New Albany Planning Commission
October 16, 2023 Meeting Minutes - Approved

Planning Commission Staff Report October 16, 2023 Meeting

CHIPOTLE FINAL DEVELOPMENT PLAN AMENDMENT

**COURTYARDS AT HAINES CREEK SUBDIVISION
FINAL DEVELOPMENT PLAN**

Previously approved site plan:

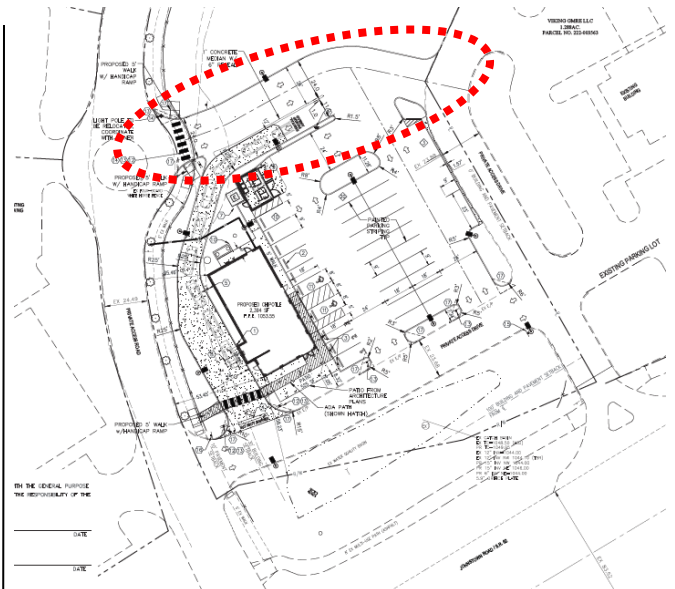
1. The drive aisle on the northern side of the site is modified to accommodate two-way traffic. This access point allows traffic to enter and exit on the private access drive shared with the Wealth Center. The applicant states that by allowing for two-way traffic north of the Chipotle building, in-lieu of one-way, it improves potential connections and access to the vacant area on the north side of the parcel. In order to provide appropriate circulation on-site with the new bidirectional traffic flow, the drive aisle:

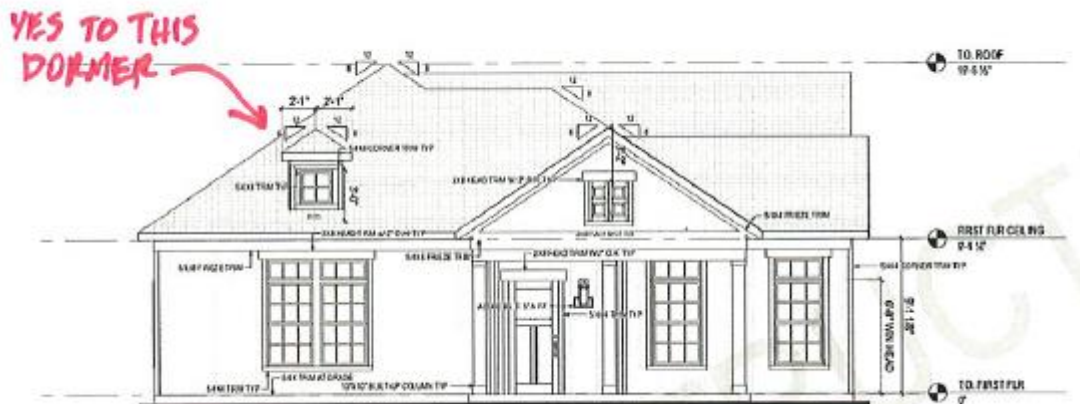
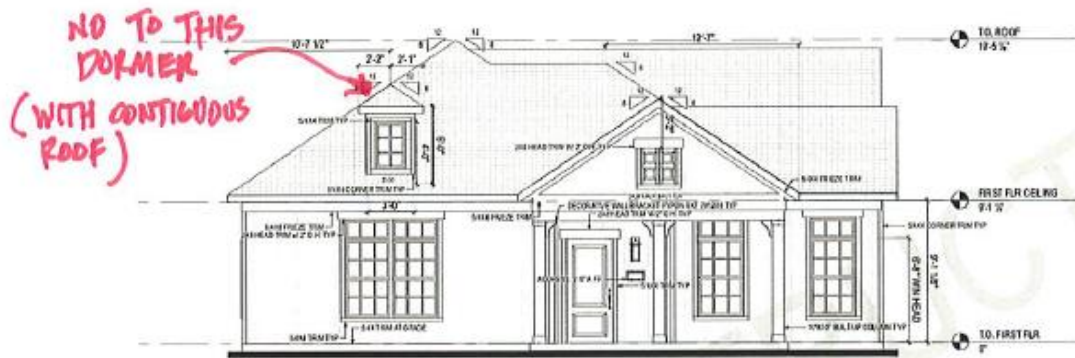
All of the setbacks required in the zoning text are accurately shown on the final development plan. The setbacks for individual homes will be reviewed and approved with each new residential building permit application.

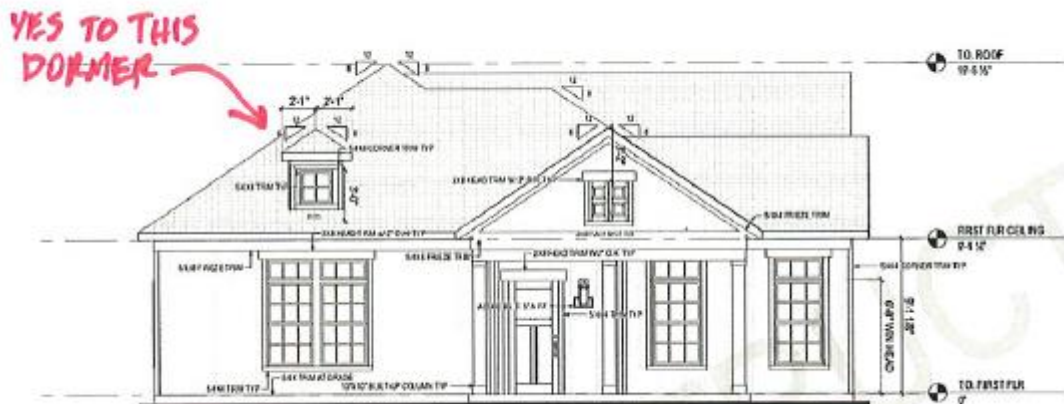
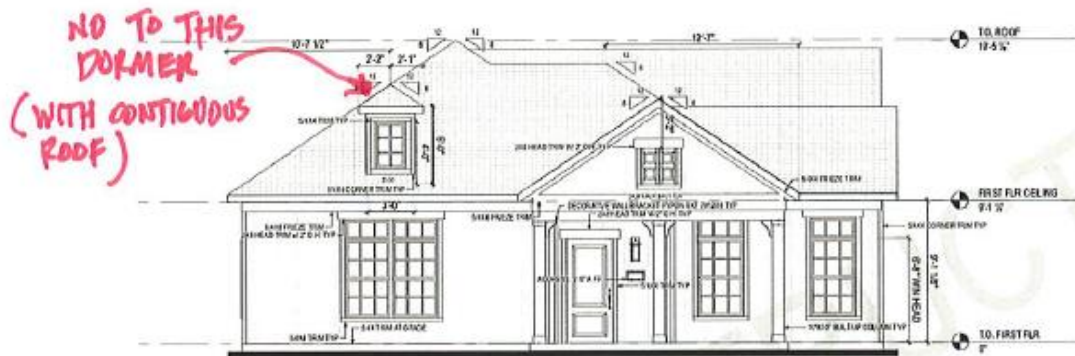
All of the setbacks required in the zoning text are accurately shown on the final development plan. The setbacks for individual homes will be reviewed and approved with each new residential building permit application.
